Application reference: 24/2825/CON

27-1053 Great West Road, Brentford, London, TW8 9BW

OFFICERS REPORT:

This report forms the consultation response to the London Borough of Hounslow associated to the above development – reference P/2023/3208

Figure 1: Estimated daily one-way construction traffic

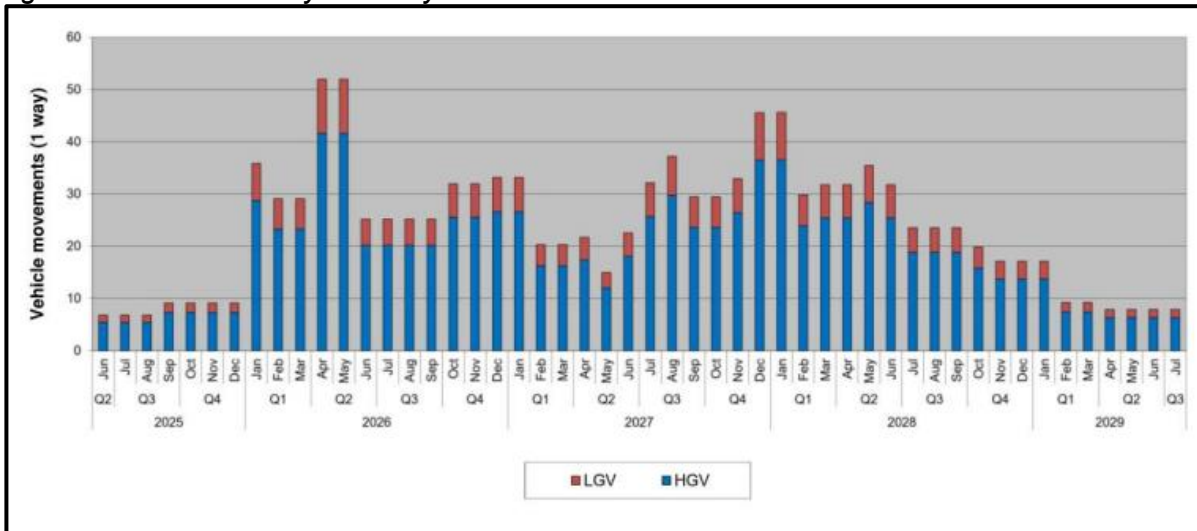
Chapter 6 of the TA concerns the outline plans for construction. Figure 1 below taken from the TA shows an estimate of the daily one-way construction trips generated. It is noted on Page 86 that construction traffic travelling from south and central London would travel via the South Circular A205. However, the TA also states that most construction traffic would be expected to enter/exit via the M4 Junction 2, so the impact should not be significant on LBRuT roads south of the river.
